UN Regulation No. 127 (Pedestrian safety)

Proposal for Supplement 2 to the 03 Series of Amendments to UN Regulation No. 127 (Pedestrian safety)

Submitted by the experts from France, Germany and the International Organization of Motor Vehicle Manufacturers *

Figure 12
Windscreen Test Area

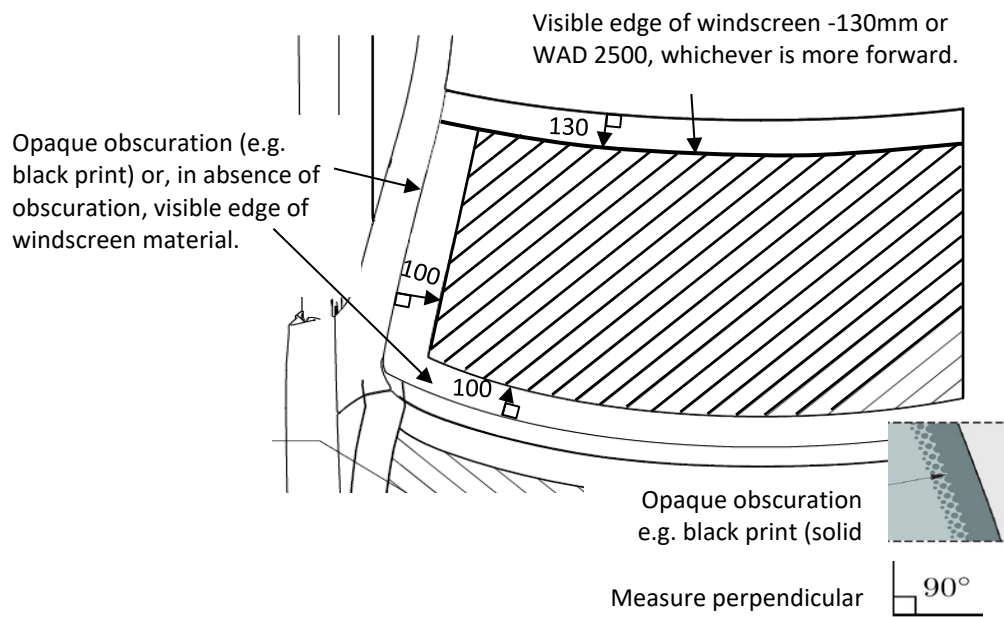
Paragraph 2.44., amend to read and insert Figures 12 and 13:

- "2.44. "Windscreen test area" is an area on the outer surface of the windscreen. It is bound (**see figure 12**):
- (a) In the front, by a line 100 mm rearward to the opaque obscuration of the windscreen. In case of absence of the opaque obscuration, the line is measured from the front visible edge of the windscreen material.
 - (b) In the rear, by a WAD 2,500 or a line 130 mm forward to the rear visible edge of the windscreen material, whichever is more forward at a given lateral position.
 - (c) At each side, by a line 100 mm inside the opaque obscuration of the windscreen. In case of absence of the opaque obscuration, the line is measured from the side visible edge of the windscreen material.

For (a) and (c): the distances of 100 mm are to be measured with a flexible tape held tautly along the outer surface of the vehicle at an angle of 90° to the tangent line to the opaque obscuration limit or in case of absence of the opaque obscuration, from the visible edge respectively.

For (b): the distances of 130 mm is to be measured with a flexible tape held tautly along the outer surface of the vehicle at an angle of 90 ° to the tangent line to the rear visible edge of the windscreen.

Figure 13
Upper Corner Definition with "Shortest Distance"

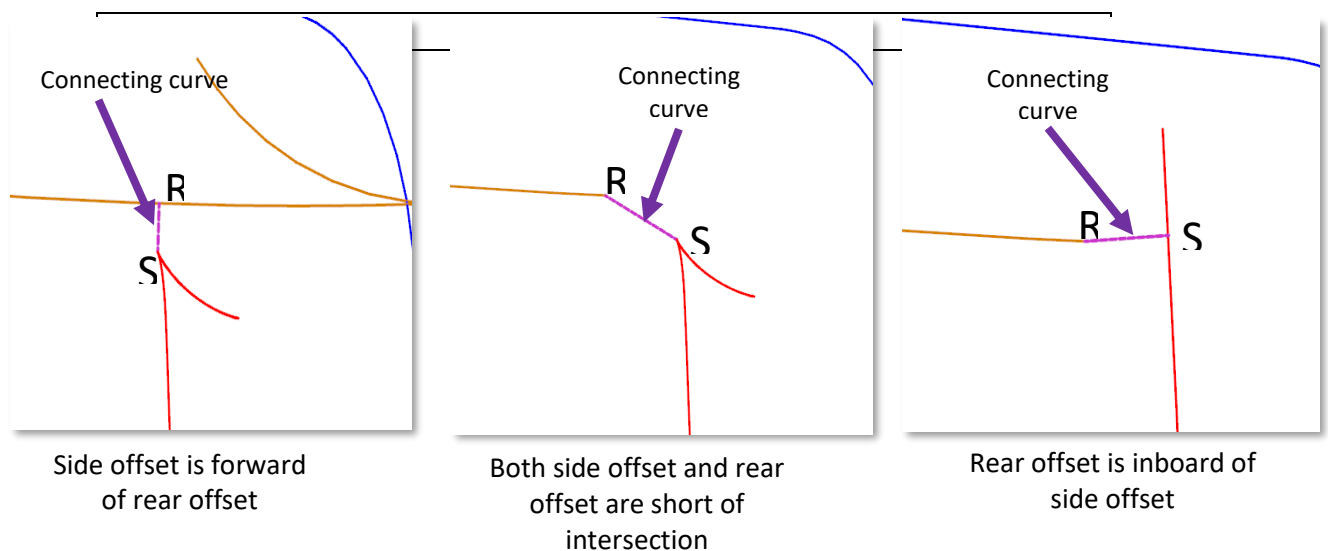
Depending on the geometry, in case there is no intersection between (b) and (c), resulting in an open test area, then the marking shall be modified using the shortest distance to close the open test area (see figure 13).

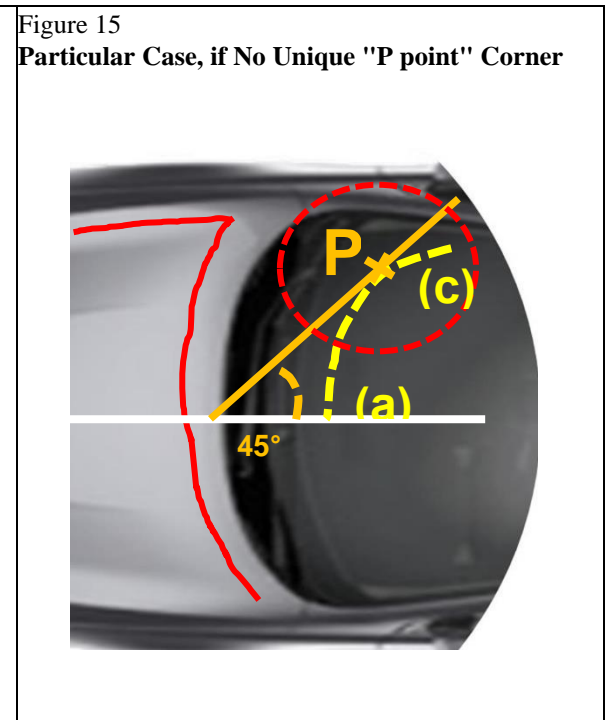
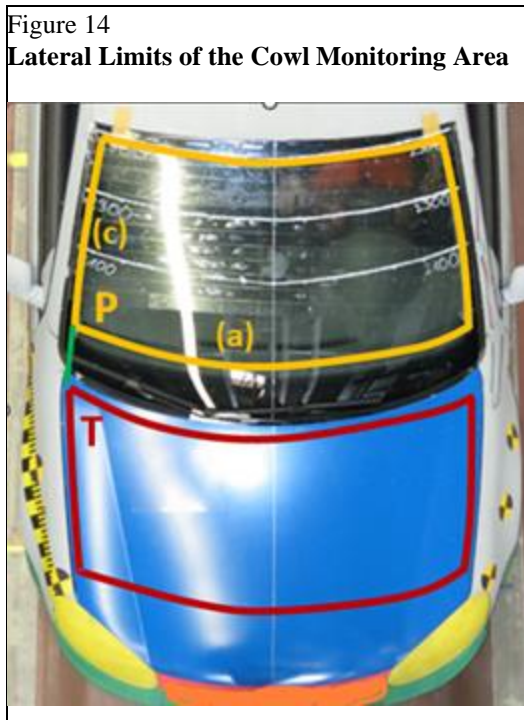
Paragraph 2.45., insert Figures 14 and 15 and amend to read:

At each side, the cowl monitoring area is bound by the TP line (see figure 14), where:

- (a) the "T point" is the rear corner of the bonnet top test area; and
- (b) the "P corner point" is the lower corner of the windscreen test area; using a flexible tape held tautly from point T to P.

If there is no unique "P point" where the lines defined in 2.44 (a) and (c) intersect, then the "P point" is defined by the first contact of a vertical plane intersecting the vertical longitudinal vehicle centre-plane at an angle of 45° with the (a)-(c) transition of the windscreen test area boundary, as shown in Figure 15.

Figure 16
Jerk Criterion Graph and Formula

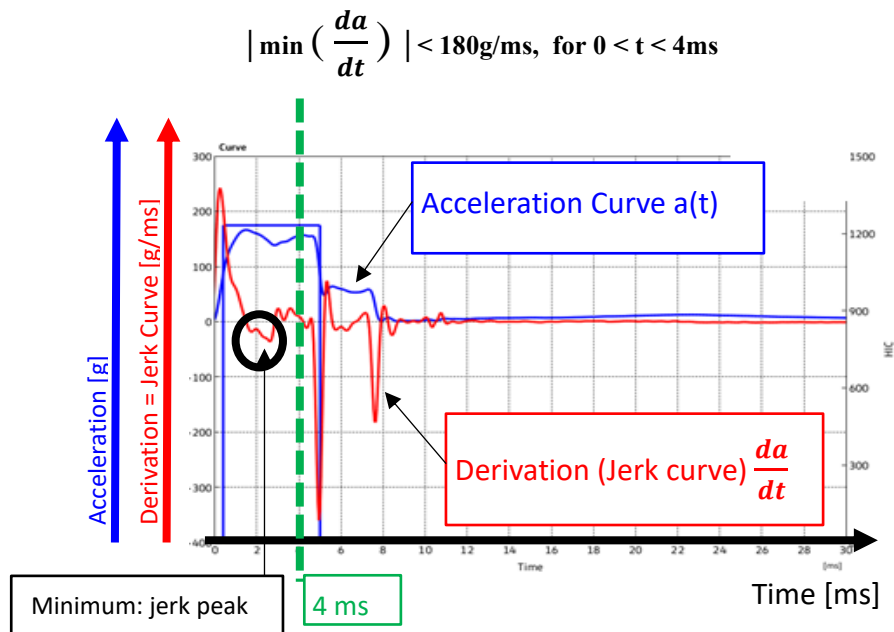
Paragraph 2.48., insert Figure 16 and amend to read:

- (a) The absolute value of the minimum value of the derivation of the headform acceleration versus time is ~~below~~ **less than** 180 g/ms ~~for~~ **within** the first 4 ms after the initial contact of the headform to the windscreen, **as shown in Figure 16** ; or

1. The proposal adapts and clarifies the existing provisions.
2. Clarification of the definition of the cowl monitoring area:
 - (a) Regarding the impactor to be used, the same WAD 1700 limit as in paragraph 2.44 "Windscreen test area" definition applies between the child and adult cowl monitoring areas;
 - (b) Editorial deletion of "any third" in annex 5;
 - (c) Addition of side limits (TP).
3. Clarification of the definition of the windscreen test area:
 - (a) Determination of the upper corners in some special cases, where the curves do not intersect; and
 - (b) Definition of the third of the area.
4. Clarification of the jerk criterion: addition of the formula and example of the graph of an atypical test.
